**Site:** 20 Prospect Street

**Case #:** PB 2019-06

## STAFF REPORT

**Applicant Name:** Union Square RELP Master Developer LLC

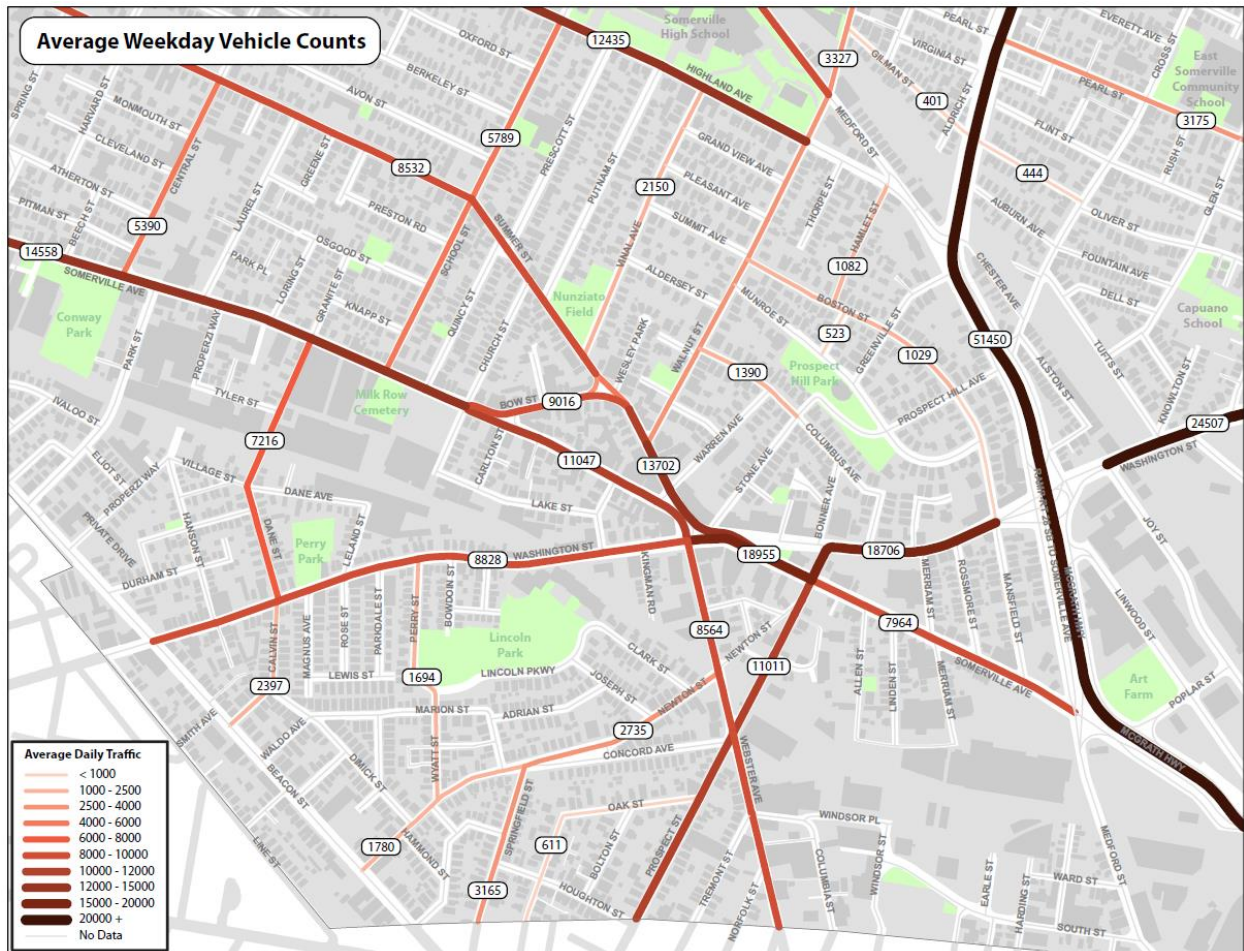
The loading and service dock for D2.2 is located in the northeast (rear) corner of the building near the intersection of Milk Alley and Bennett Court. The tandem two bay loading area is designed for WB-40 tractor semi-trailer trucks, but will also be able to accommodate single unit box trucks and waste pick-up vehicles. Primary access for the loading dock is proposed to enter the alley system to and from Somerville Avenue. Bennett Court is proposed to accommodate access to and from Prospect Street, but deliveries are intended to be coordinated by the owner or future property management firm to occur at off-peak hours.

Single unit box trucks are able to enter and exit the alley system at Bennett Court or Milk Alley with little interference to opposing traffic on Prospect Street and Somerville Avenue and can easily reverse maneuver into the loading dock.

Tractor semi-trailer trucks are able to enter the alley system without crossing into oncoming traffic lanes by making a left turn into Milk Alley from Somerville Avenue when traveling west, a right turn into Bennett Court when traveling north on Prospect Street, and a left turn into Bennett Court when traveling south on Prospect Street. Turning right into Milk Alley when traveling east on Somerville Avenue requires a WB-40 truck to infringe both the west-bound travel and turning lanes of Somerville Avenue. To enter the loading dock of D2.2 from southbound travel on Milk Alley requires the WB-40 type truck to make a complex four-point turn to reverse direction using Bennett Court. To enter the loading dock from Bennett Court requires a less complex reverse maneuver into the loading dock.

When exiting the loading dock, a WB-40 truck type will have to turn left and exit the alley system via Milk Alley onto Somerville Avenue. Regardless of exiting direction, this truck type will infringe on traffic movements in opposing lanes temporarily.

### Pedestrian Level Wind Analysis

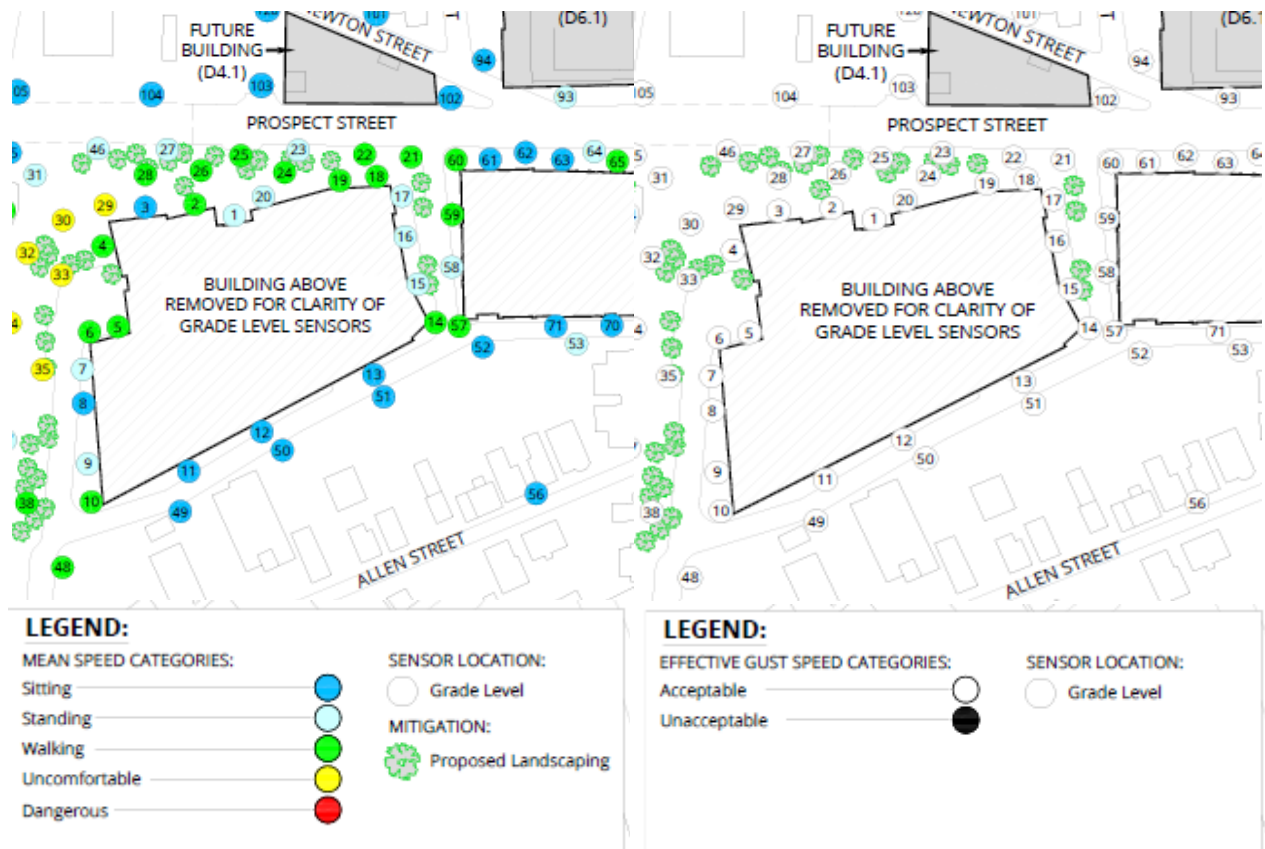
The Applicant submitted a pedestrian level wind study prepared by Rowan Williams Davies & Irwin Inc. The City requires a wind analysis to determine the suitability of various locations for various activities (e.g., walking, sitting, standing, etc.) and requires that mean wind speed and effective gust speeds not be exceeded for particular activities more than one percent (1%) of the time without mitigation. Wind statistics recorded at Boston Logan International Airport are used to estimate wind characteristics for the D2 site. The development of D2.2 is not specifically called out as increasing wind speeds.
